Southern California Edison Company

Subject: Docket No. 50-206
Updated Single Failure Analyses
San Onofre Nuclear Generating Station
Unit 1

The purpose of this letter is to transmit page changes to the reports entitled, "Engineered Safety Features Single Failure Analysis, San Onofre Nuclear Generating Station, Unit 1," and "San Onofre Nuclear Generating Station Unit 1, Reactor Protection System Single Failure Analysis" to reflect the reanalyses caused by several of the Cycle 10 modifications.

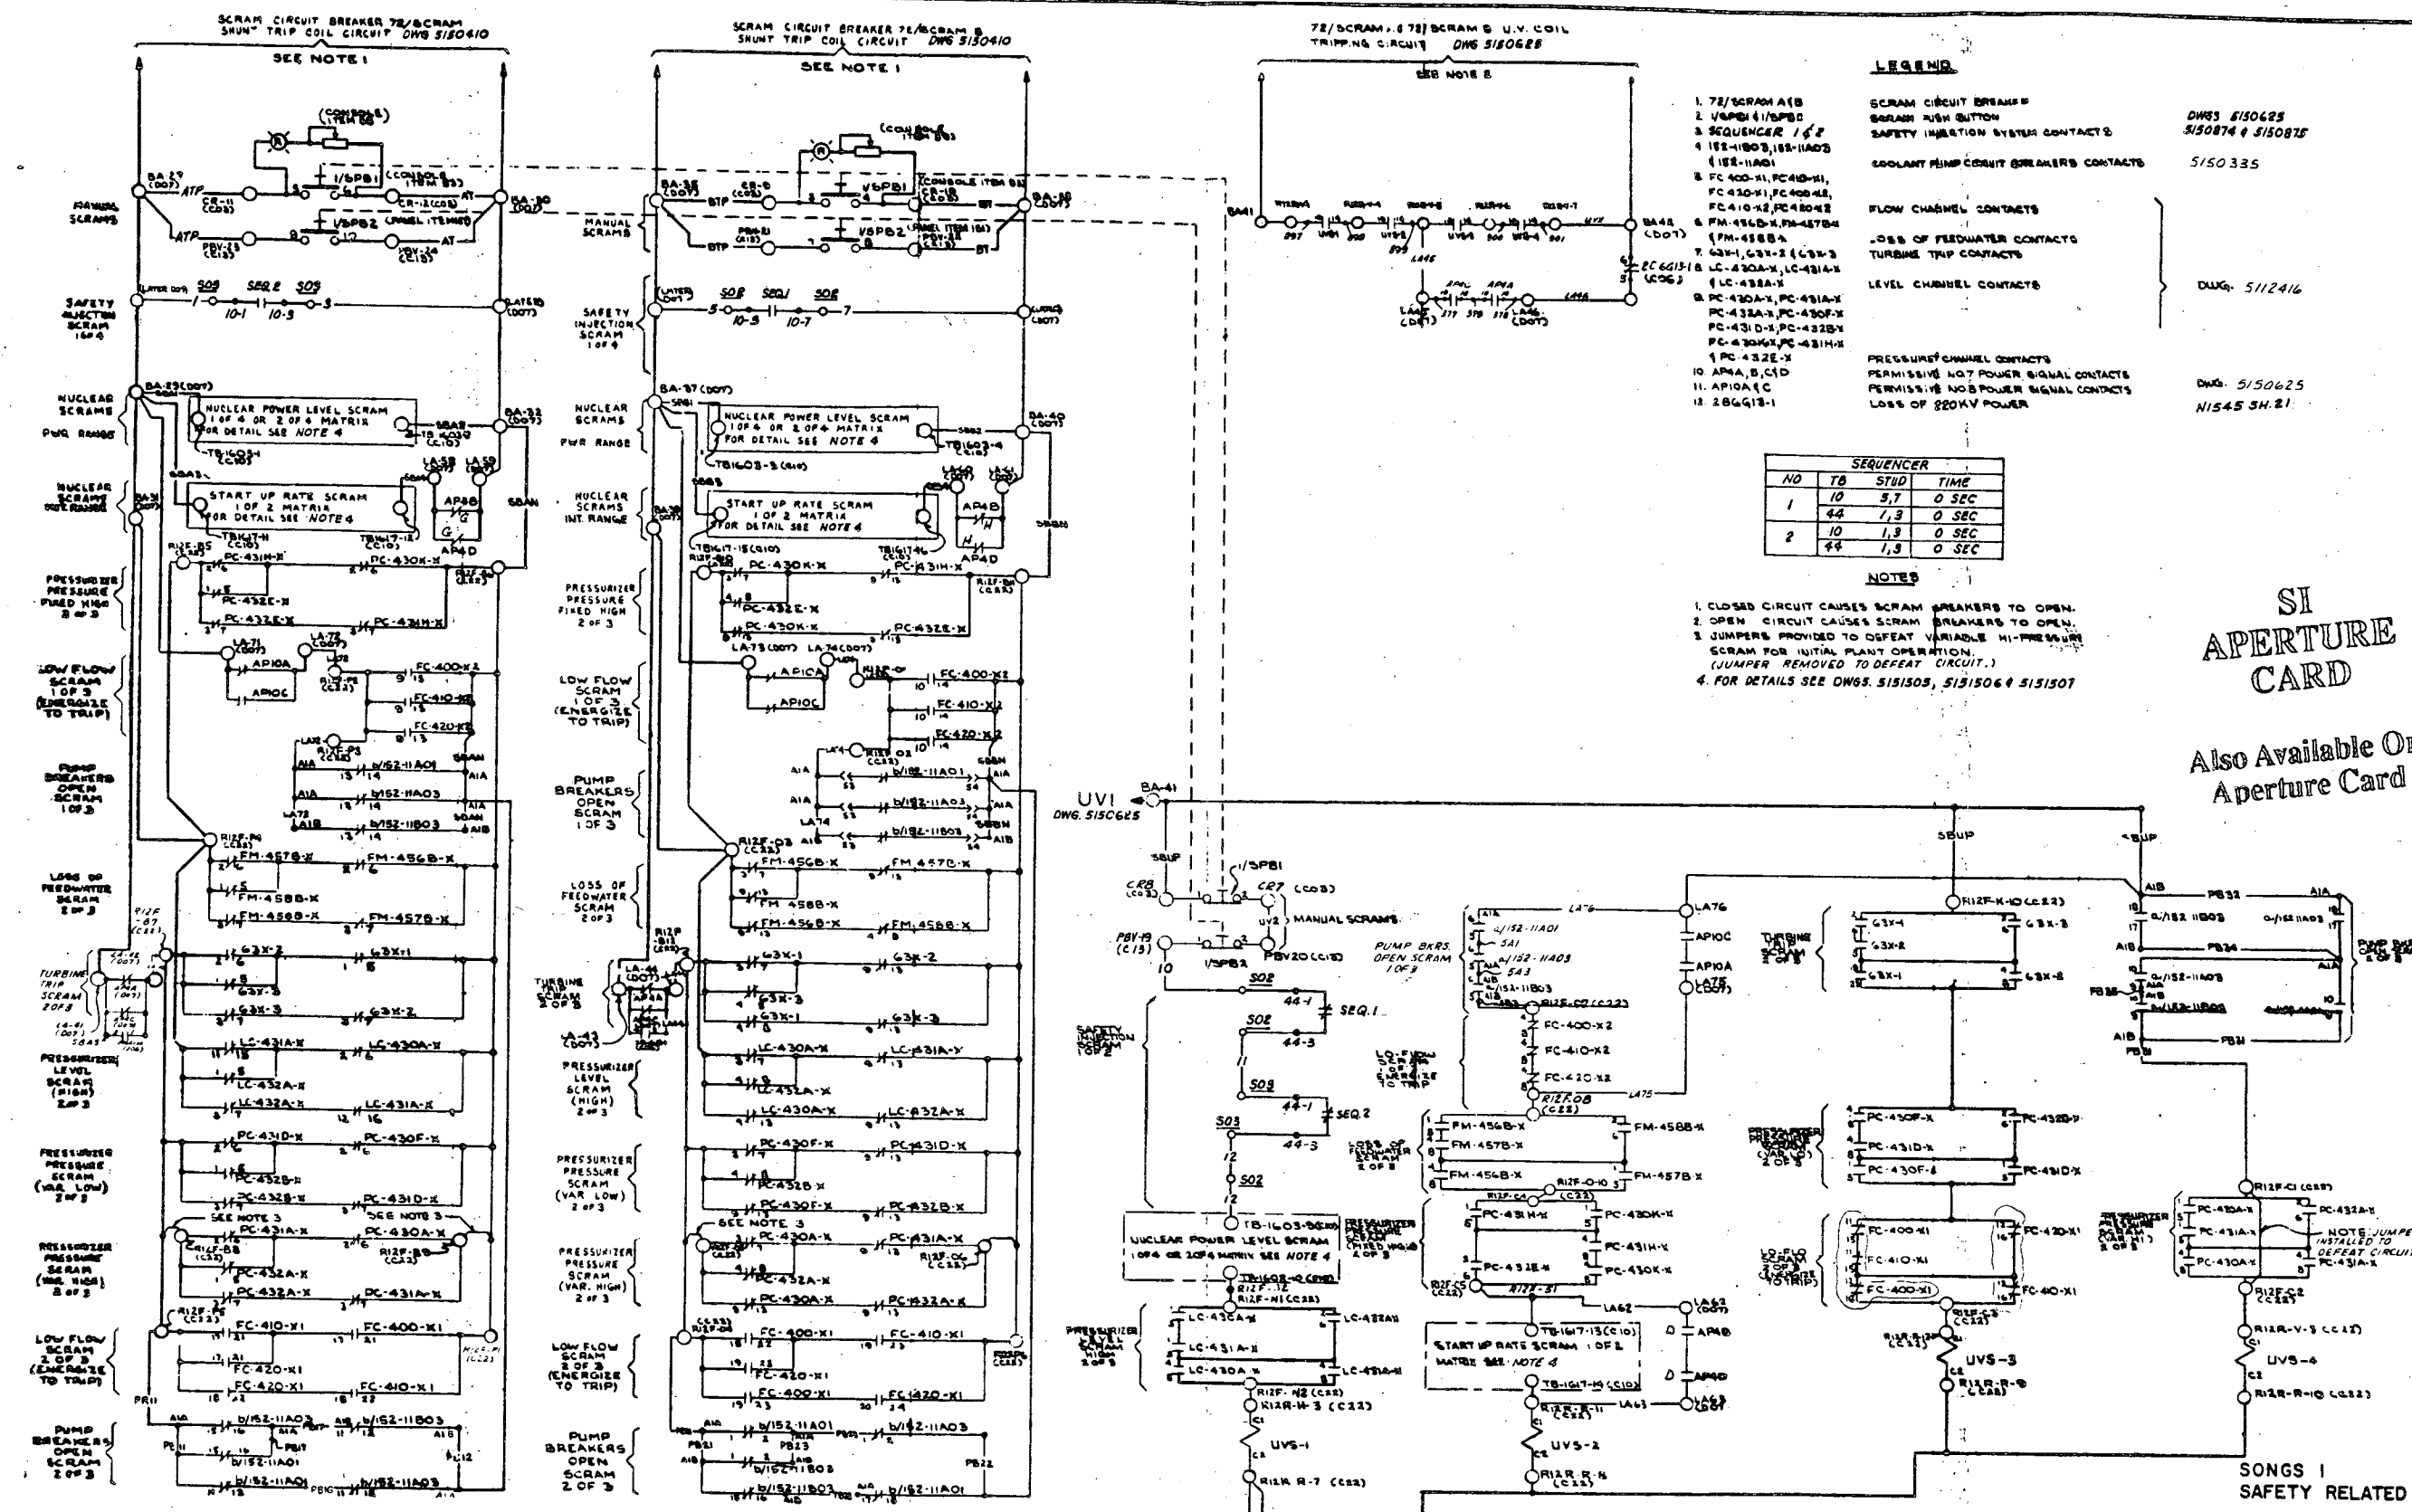
FIELD TO REMOVE FUSES AND LAMICOID TAGS FROM REGULATORS PREVIOUSLY USE FOR NIS.

DCP 1-2003 DBT REV. 0 SHEET 648

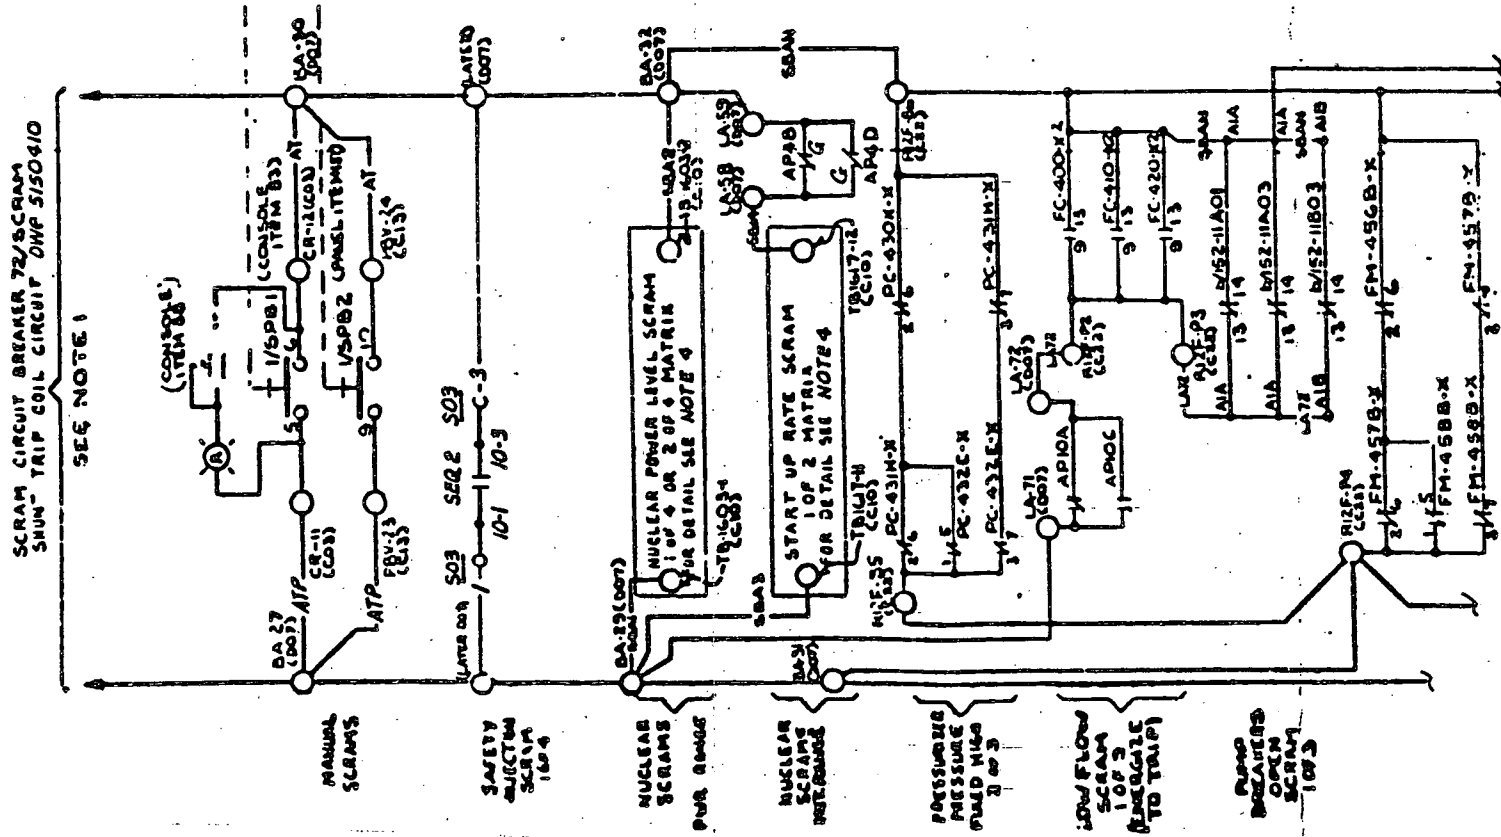
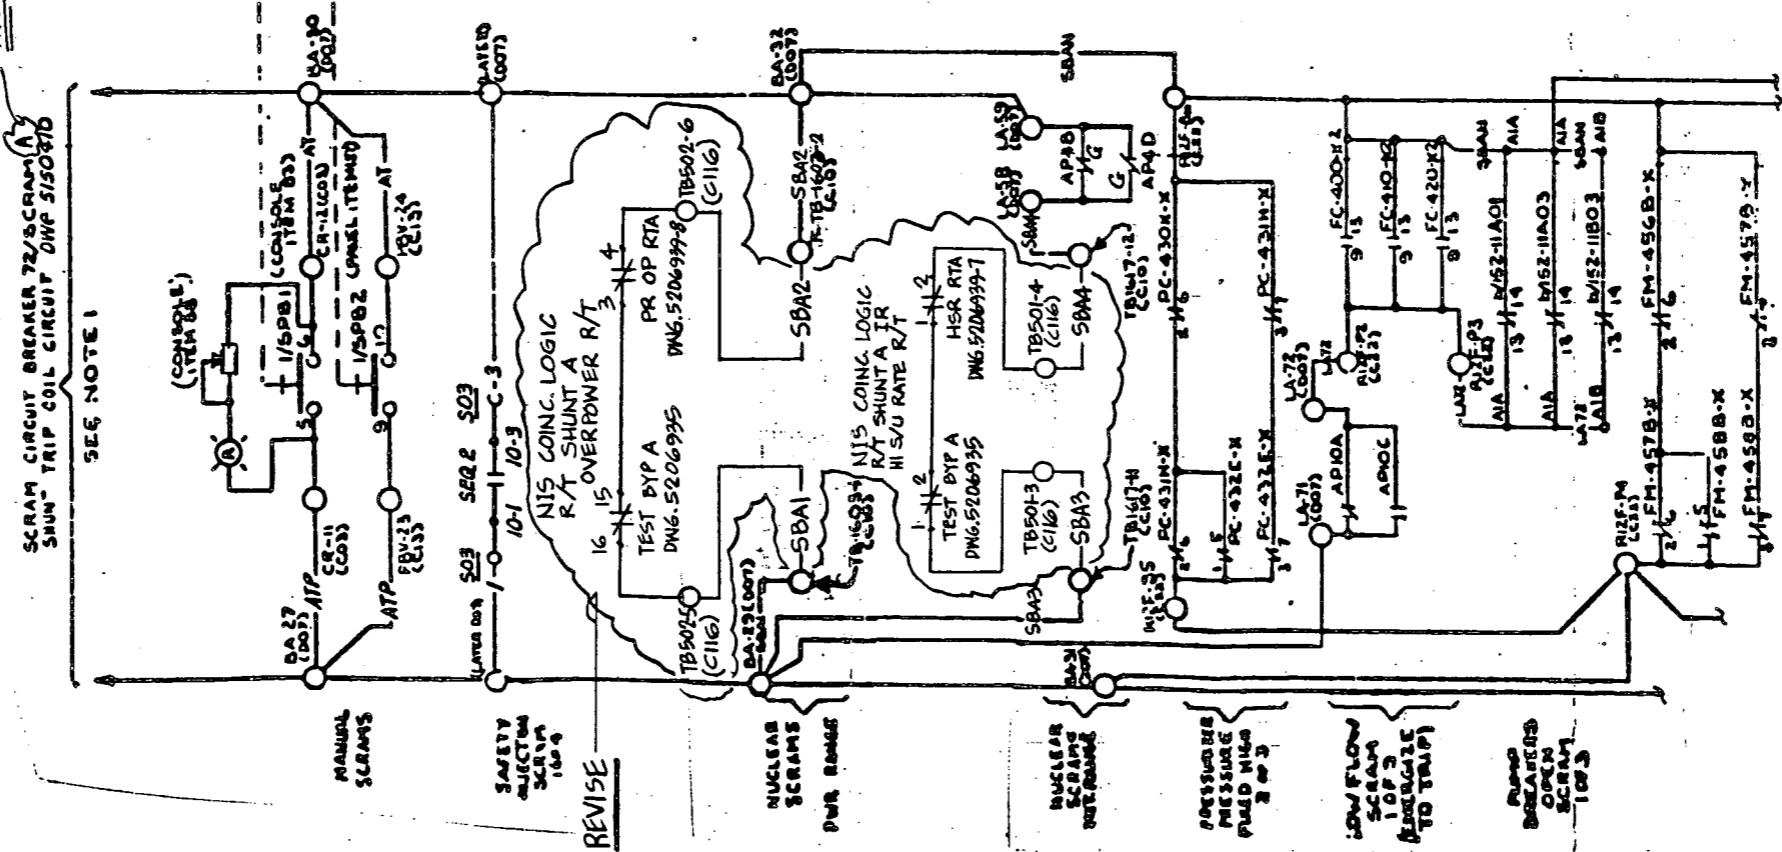
DESCRIPTION OF CHANGE

DWP 1-3003.08J REV 0 SHEET 670

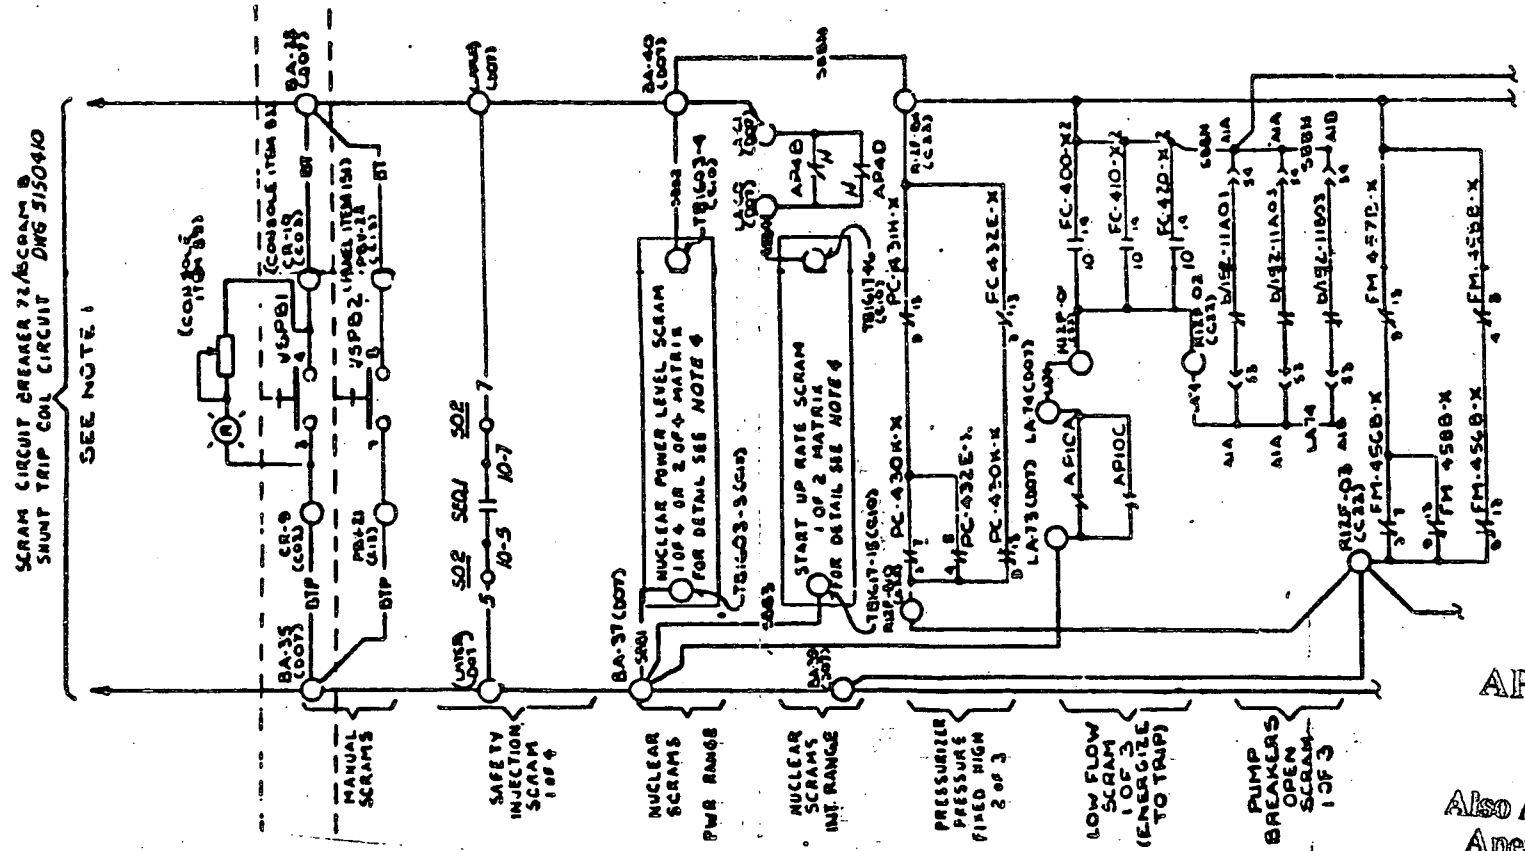
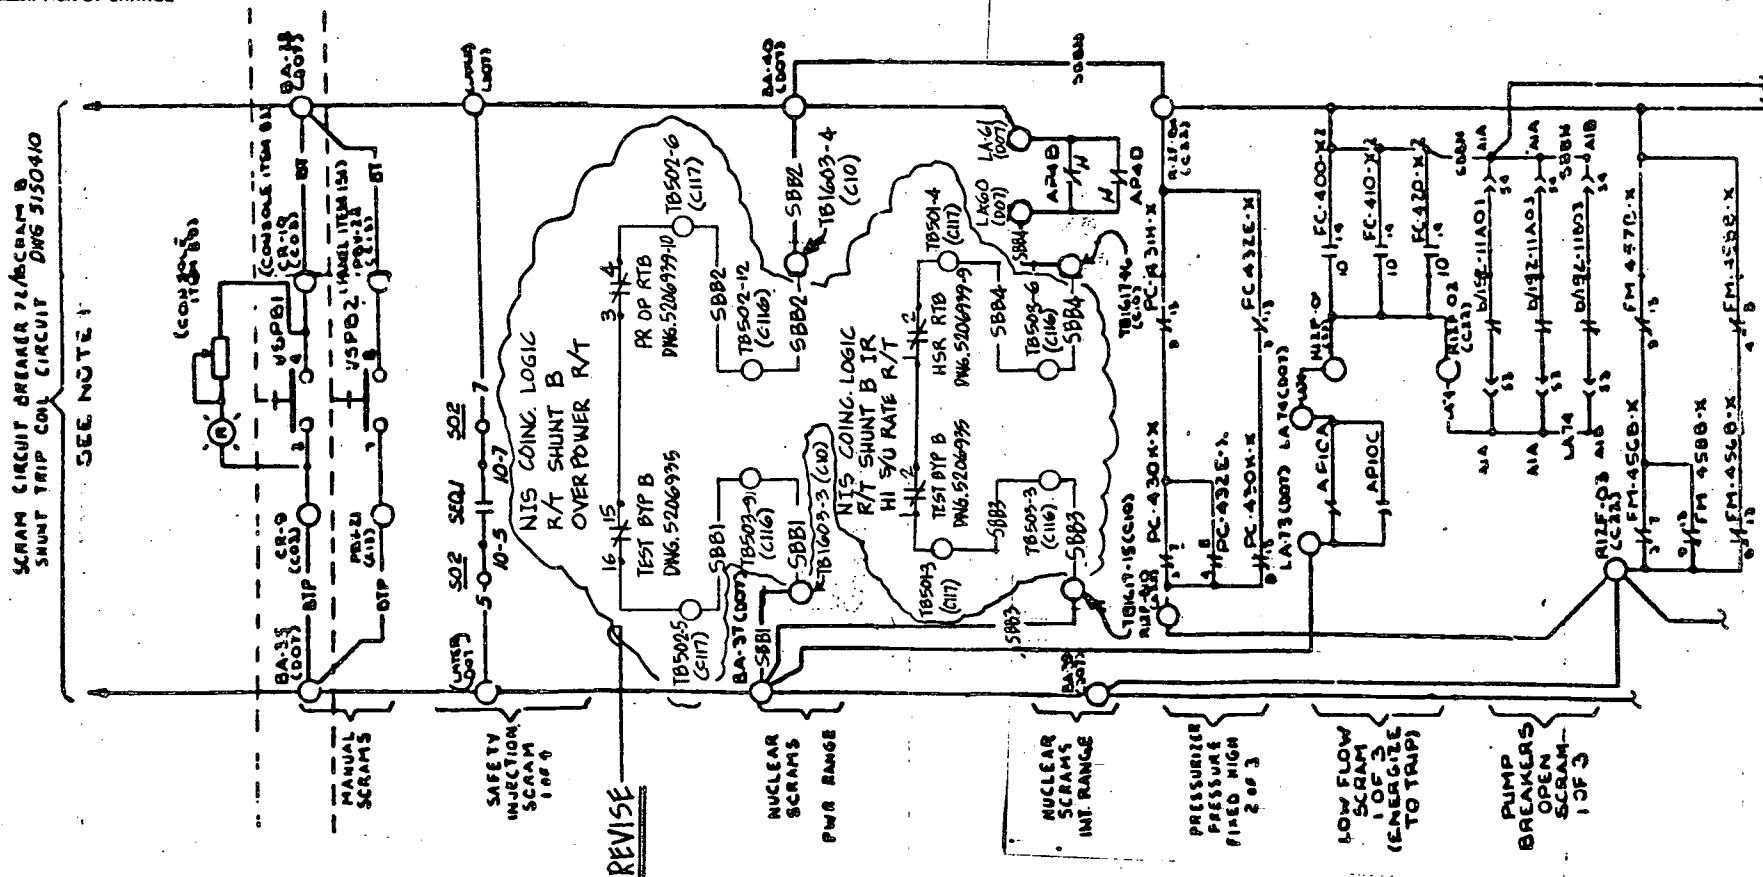
DESCRIPTION OF CHANGE
